14 February 2022

Reference: New Liverpool Primary School SSD-10391 Response to Transport Related Submissions

Figure 2 Pedestrian travel path between the preschool and the proposed 15-minute on-street parking spaces on Lachlan Street

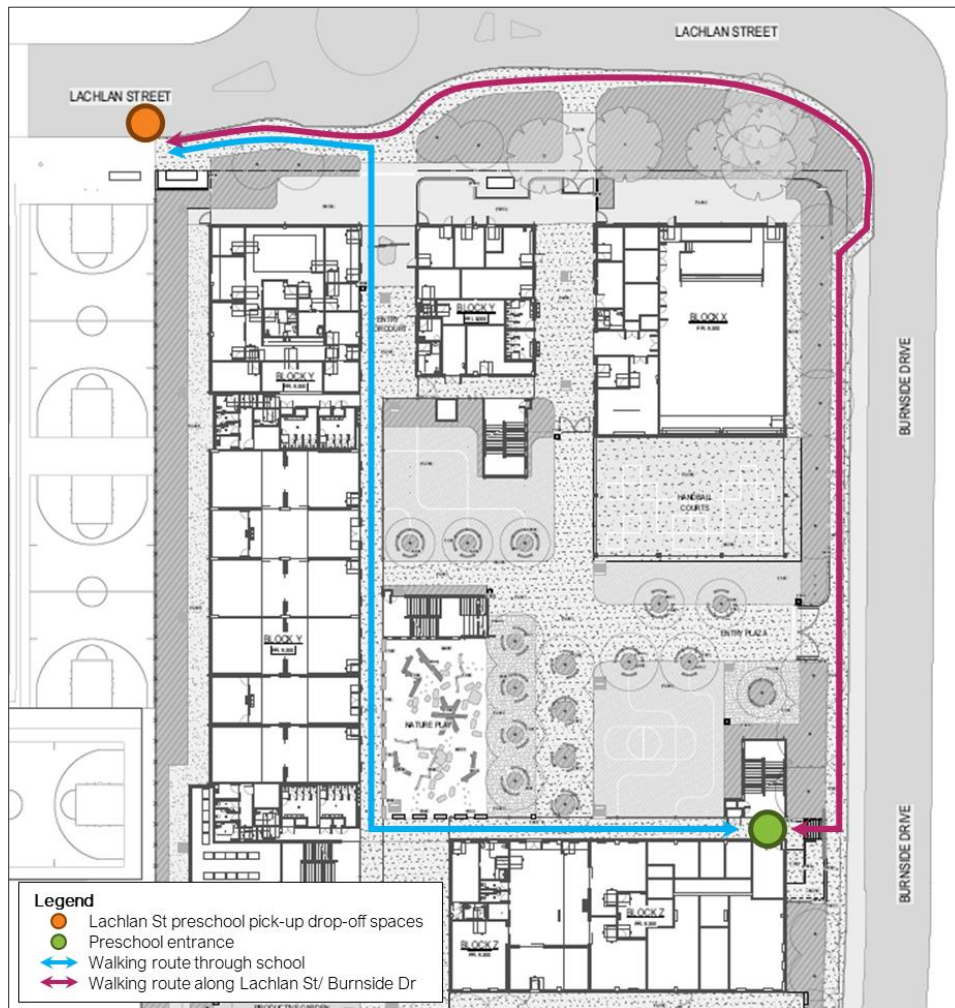
The Department requested additional information regarding parking facility for the preschool users or else an alternate area is to be identified where parents can park during arrival/ departure (when coinciding with the school drop-off/pick-up times). Please address this issue. The response to RFI letter says designated preschool parking spaces of 15mins length of stay will be provided between the hours of 7am to 8:15am and 4pm to 6pm adjacent to the school on Burnside Drive. A detailed study is required for capacity of parking on burnside drive between this time.

Pedestrian paths will be provided connecting the on-street parking spaces on Lachlan Street to the preschool, with the various walking routes shown in Figure 2. These routes equate to a walking distance of approximately 160 metres (through the school site) to 190 metres (along Lachlan Street and Burnside Drive). In Australia the typical walking speed used for determining pedestrian walk time is 1.2 metres per second (Austroads and Transport for NSW), this equates to a walking time of around two minutes

10 seconds to two minutes 40 seconds (depending on which school access is used) which is considered minor, and would allow time for parents/ carers to walk their child into the preschool and return to their car within the 15-minute time limit (or pick-up their child and return to their car).
